Re: Nicolas Perpepaj  
601 Bedford Road  
Section 101.02, Block 2, Lot 52

The following are our responses to your comment letter of April 6, 2024:

PROPOSED SEPTIC PLAN  
PREPARED FOR  
**NICHOLAS PERPEPAJ**  
PROJECT LOCATION  
601 BEDFORD ROAD  
Town of North Castle  
Westchester Co., New York

**SITE PLAN**

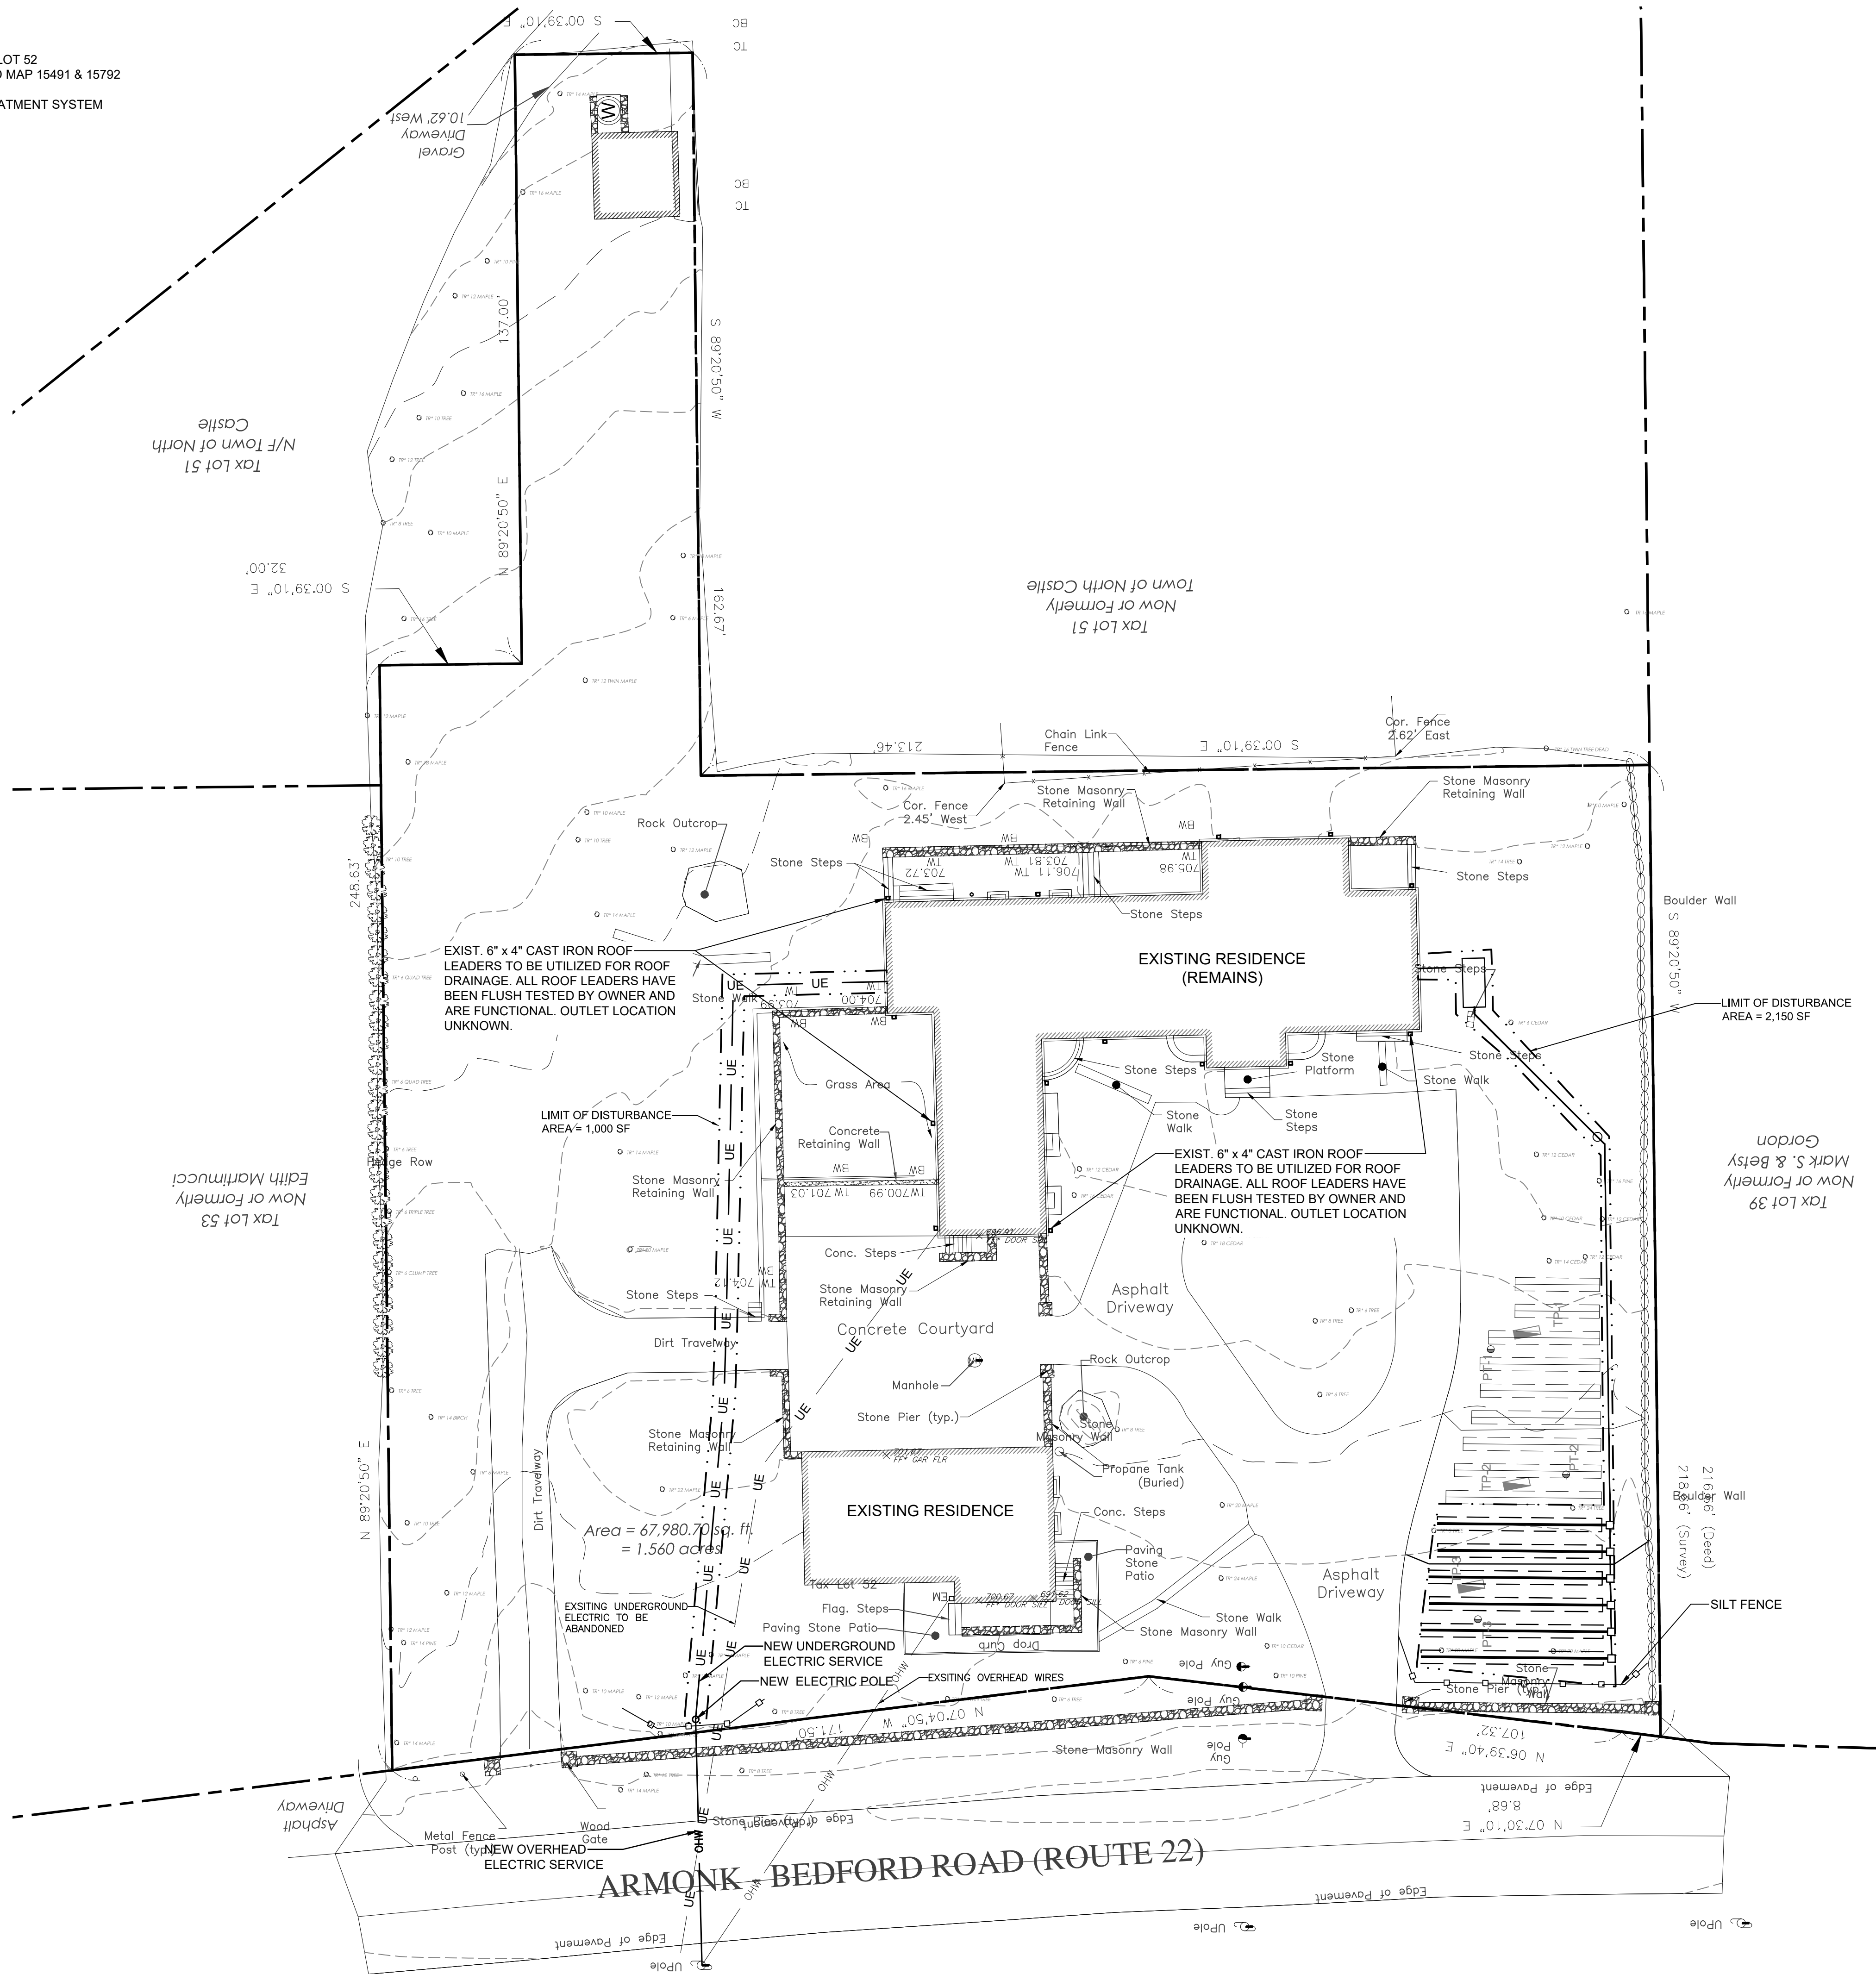
1. The intent is to use the existing original roof drain system. As the Town is aware the original structures are quite old and predate any approvals for drainage. As a result of a request from the Building Department no records exist. Therefore, we cannot verify the final discharge point. There are several cast iron 6"x4" leader standpipes that are located around the existing structure which have been added to the site plan. The owner has flow tested these and they are all operational. As stated, the final point of discharge is unknown as it is subterranean. During the flow test no water was seen backing into the basement of the structure or on the ground surface.

**SEPTIC PLAN AND GENERAL NOTES**

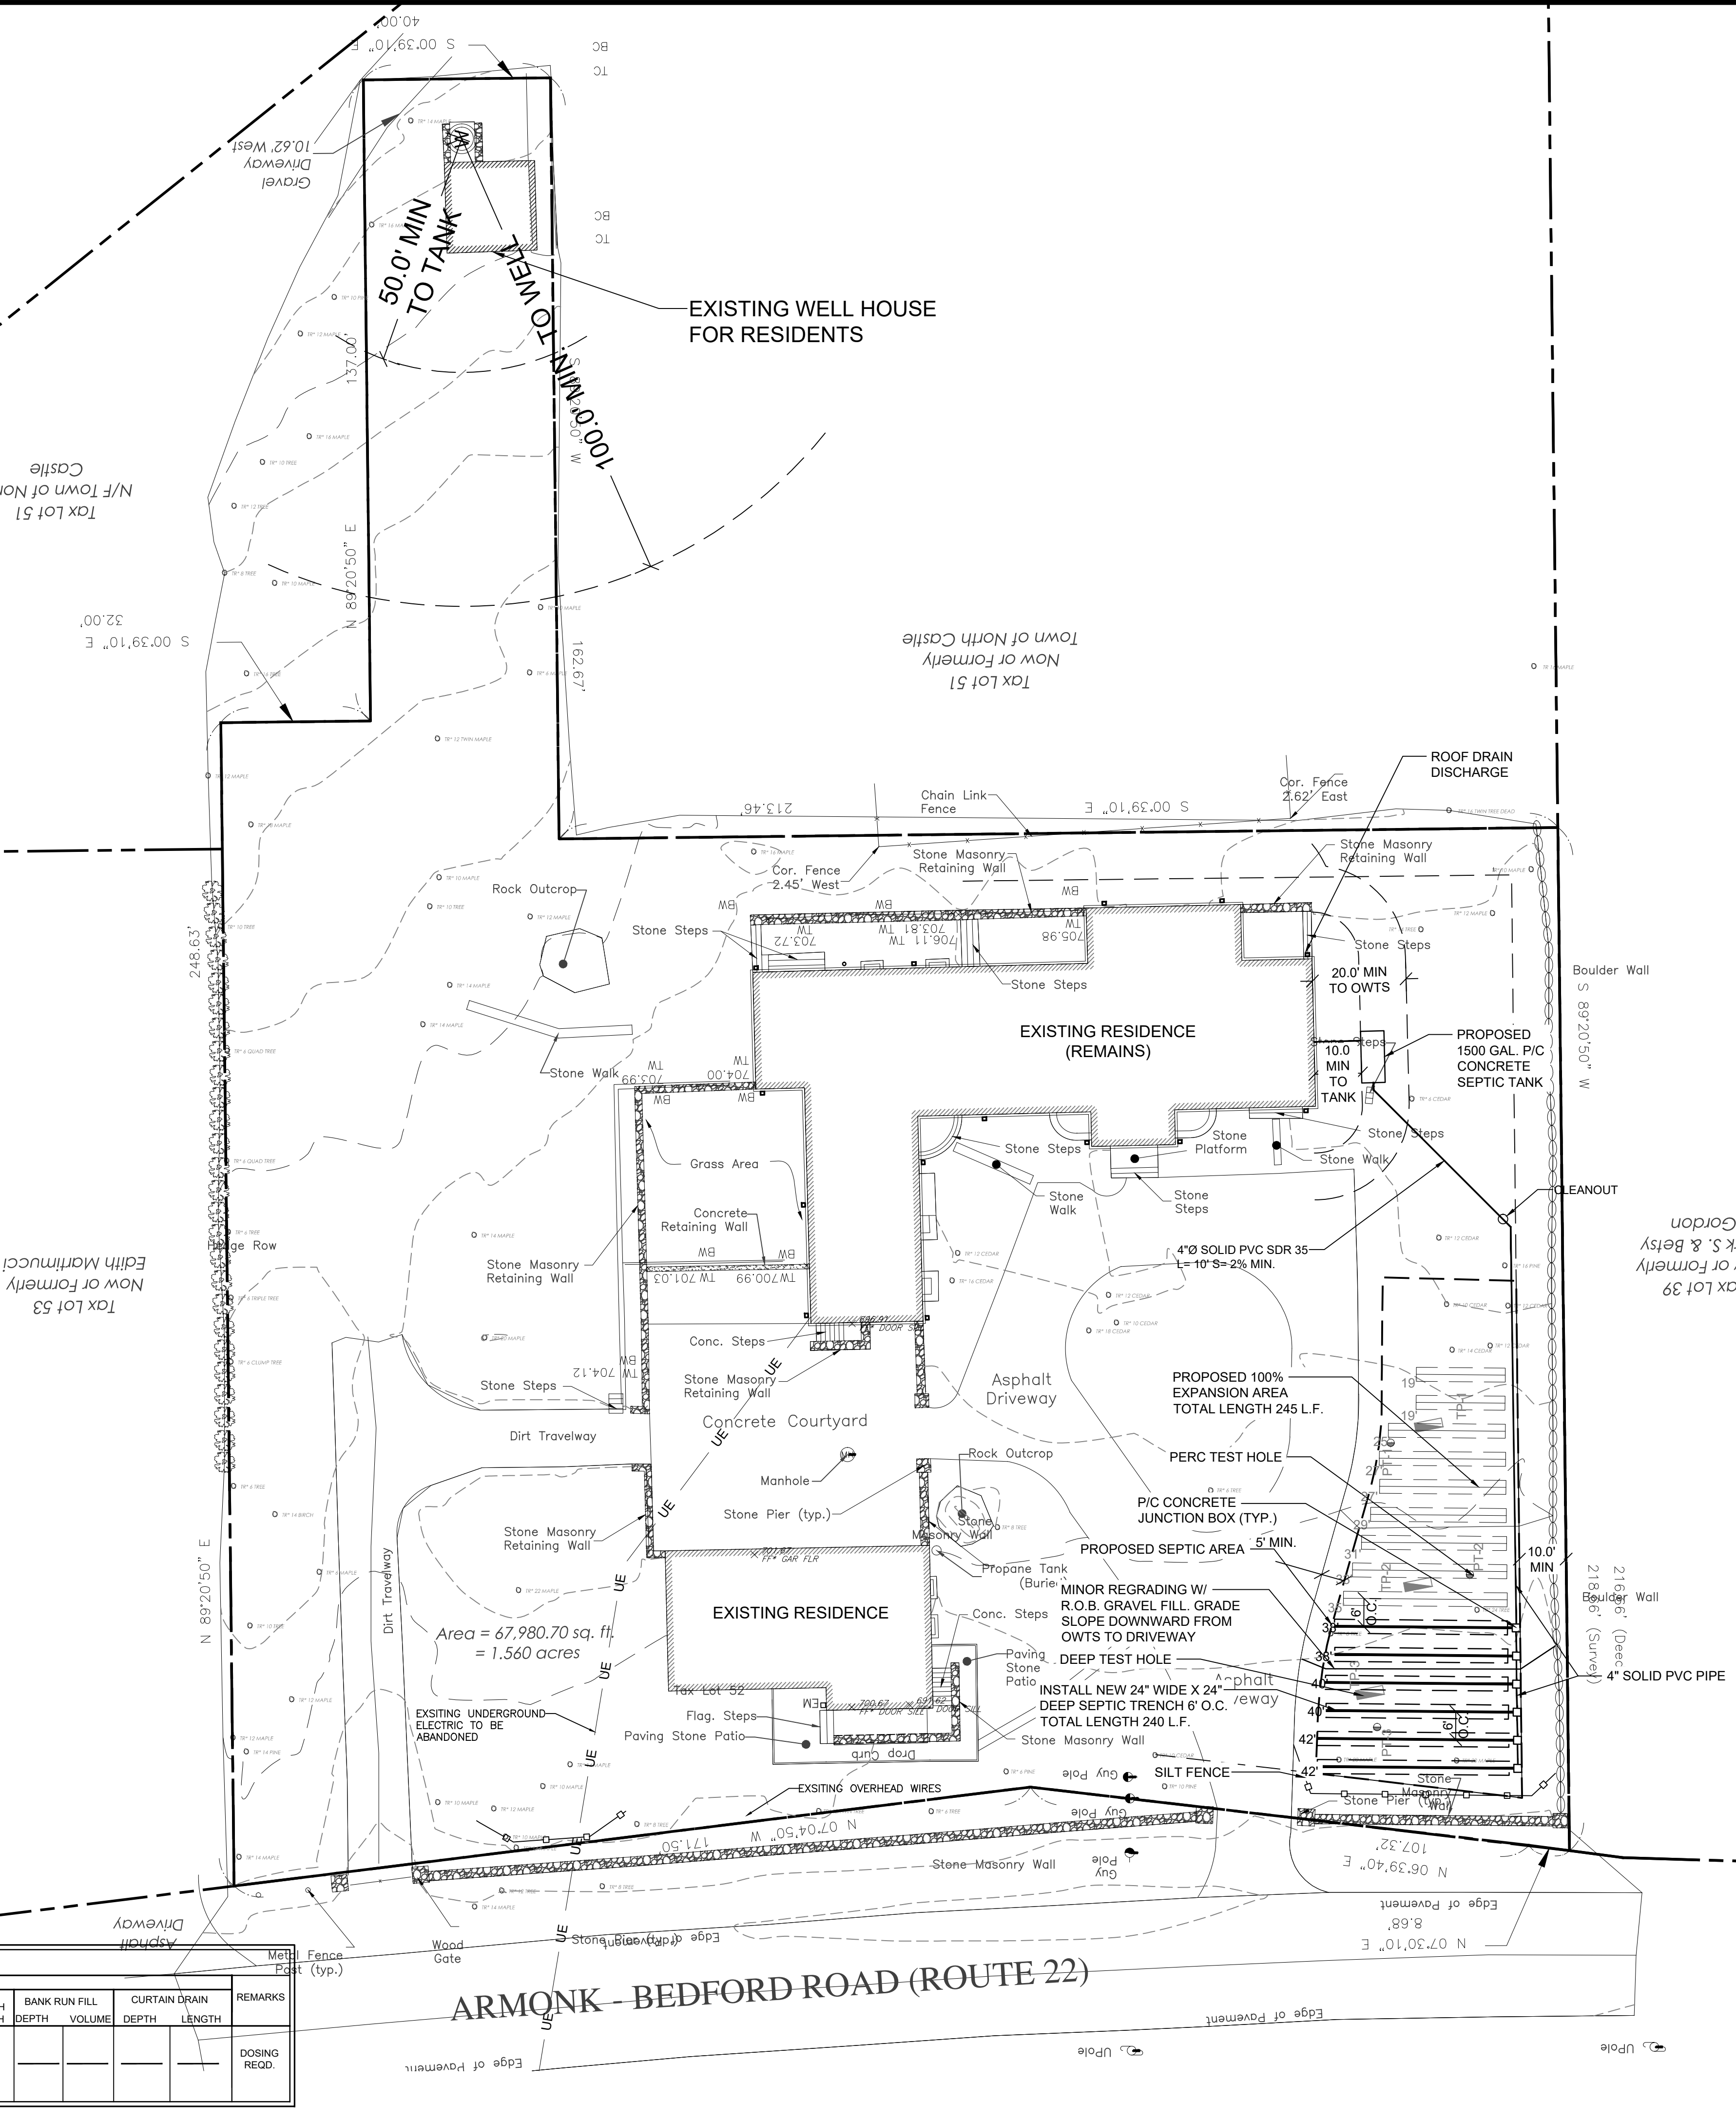
2. The location of the septic system is currently unknown. The tank for the cottage is located in the concrete courtyard between the two buildings. The owner had previously submitted a record request from the Health Department with no response. We have separately filed for a record search of the Health Department records, but it is unlikely that anything exists. We were told by Tony Kunny at the Health Department a few months back that to get a letter of no objection he would be satisfied with an inspection report from a licensed contractor but that isn't possible without a large undertaking since the courtyard is concrete. United Septic was hired to investigate the system. They found that the septic tank in the courtyard is over 4 feet deep and constructed of brick and an attempt to scope it failed because they could not get to the outlet end. The only way to go any further would require digging up the courtyard, which is not desirable. The cottage has been occupied for at least the time my client has owned it and there is no issue with sewage showing up anywhere so there must be a system somewhere. As you know we have a septic permit for the main house and the HD did not question the cottage septic. It is not possible to almost double the proposed septic system to accommodate the cottage also. There was a line on the drawing indicating a drain connected to the septic tank which was not correct and has been removed.

3. The existing and proposed utilities are now shown.

**E-1** SILT FENCE DETAIL  
NOT TO SCALE

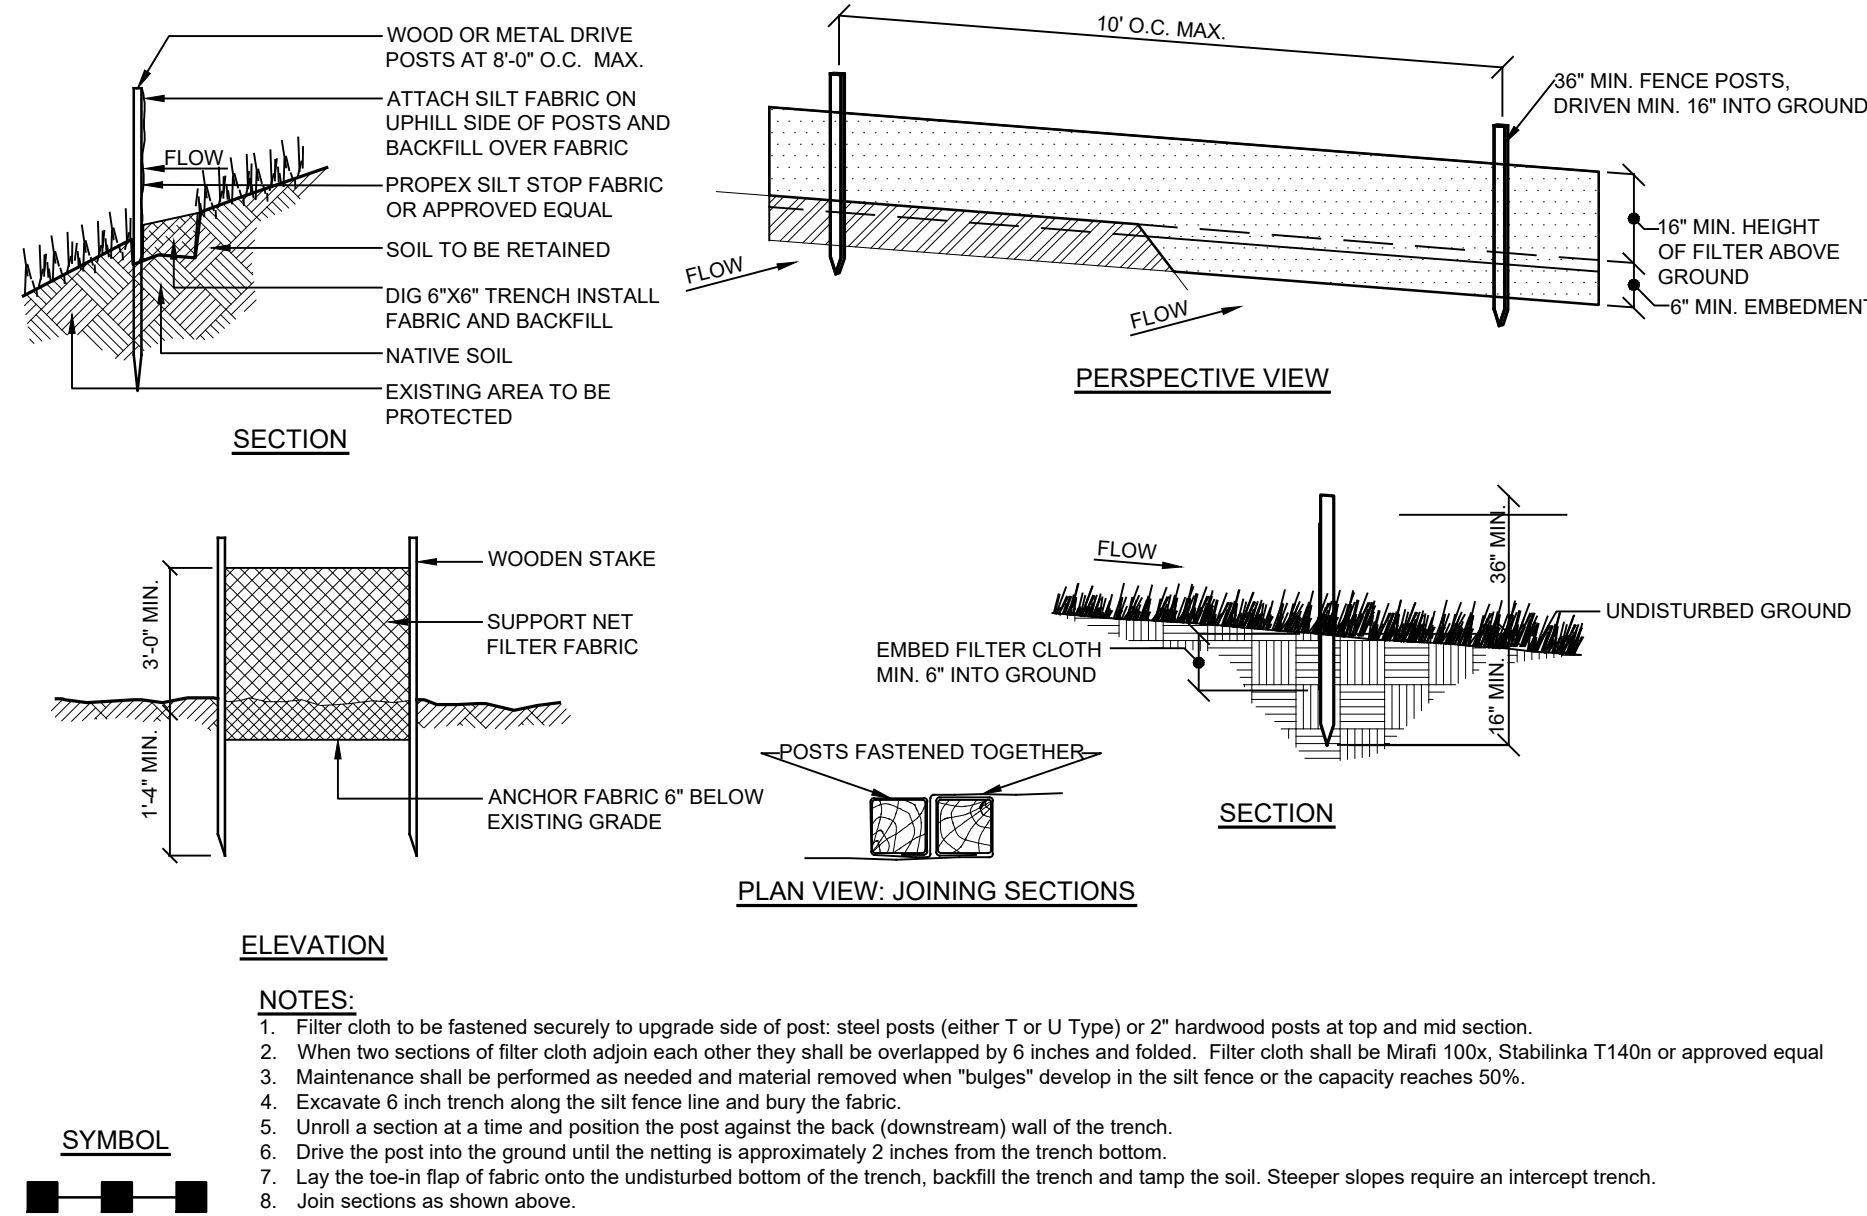
4. There is not a significant amount of disturbance proposed. The only disturbance relates to the installation of the proposed septic system and the underground utility services. A silt fence is proposed in these locations. A silt fence detail and restoration notes have been added.
